Sent: 9/12/2022 4:35:07 PM
Subject: Submission re: 24 Oliver Street, Freshwater
Attachments: 24 Olivier Street, FRESHWATER - Submission.pdf;

**RE: DEVELOPMENT APPLICATION DA (DA2022/1710)
PROPOSED CONSTRUCTION OF 2 DWELLING HOUSES
24 OLIVER STREET, FRESHWATER**

Image 1: Side setback map. Only areas mapped as 'N' are a merit assessment of the side setbacks proposed.

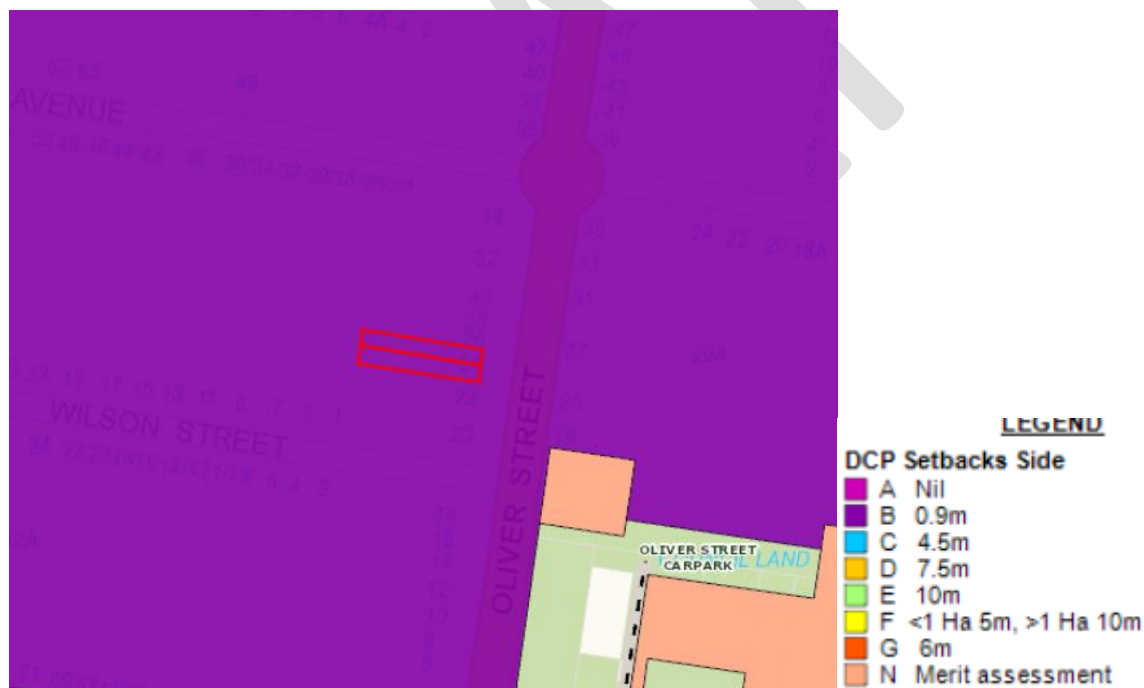
I note that the statement of environmental effects does provide commentary with regard to clause B6 of the DCP however that clause does not apply to the site. The merit assessment of side boundary setbacks only apply to sites that are mapped as being a 'merit assessment' of side setbacks. This means that sites mapped as having no numerically prescribed setbacks are to be assessed on their merits. A 900mm side setback applies to the site and the objectives of clause B5 are what the development will be assessed against.
